PERMIT
SHARED SEPTIC SYSTEM

Tax ID # 5449332
HOUSE SEWER LINE CONNECTION

HOWARD COUNTY HEALTH DEPARTMENT
BUREAU OF ENVIRONMENTAL HEALTH

SUBDIVISION Walnut Grove LOT NUMBER: 69

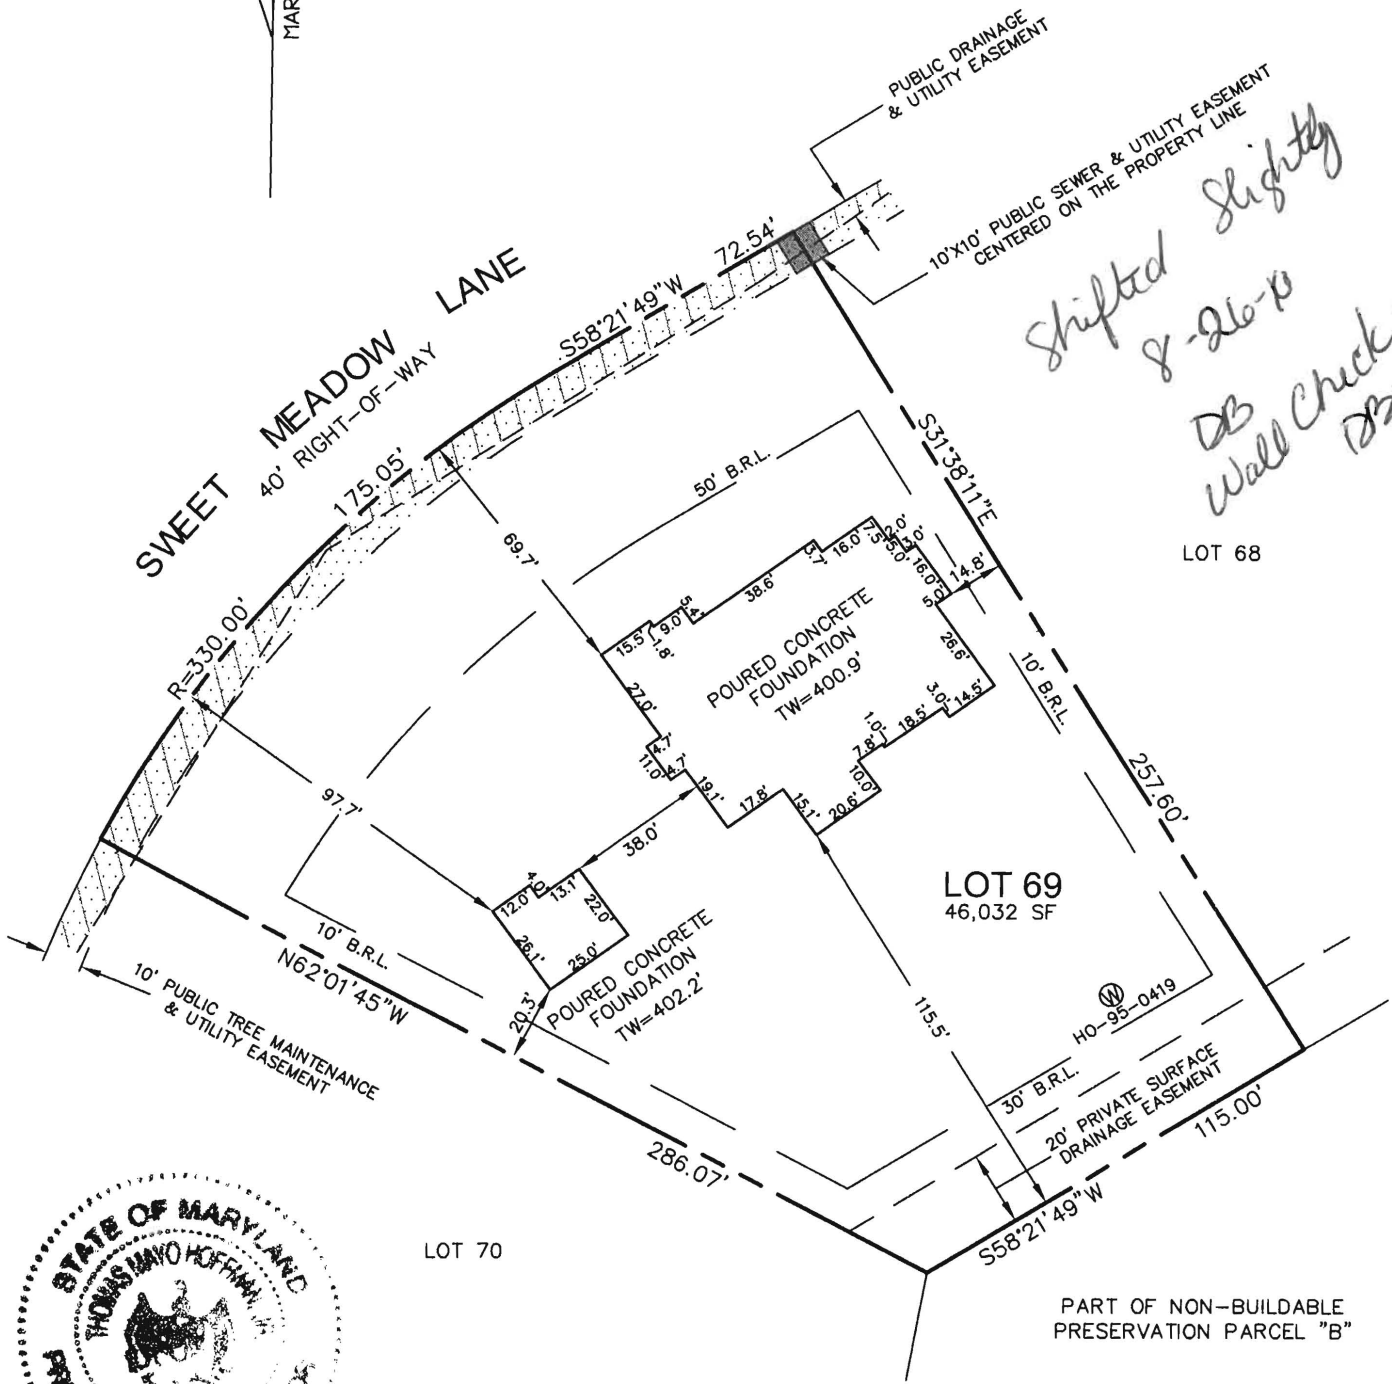
3/9/11 2% fall throughout 4" sch 40 sewer line. Everything looks good ok to backfill. Need p/A on grinder prior to spread (K)

*Shifted slightly
8-26-10
DB Wall Check OK
DB*
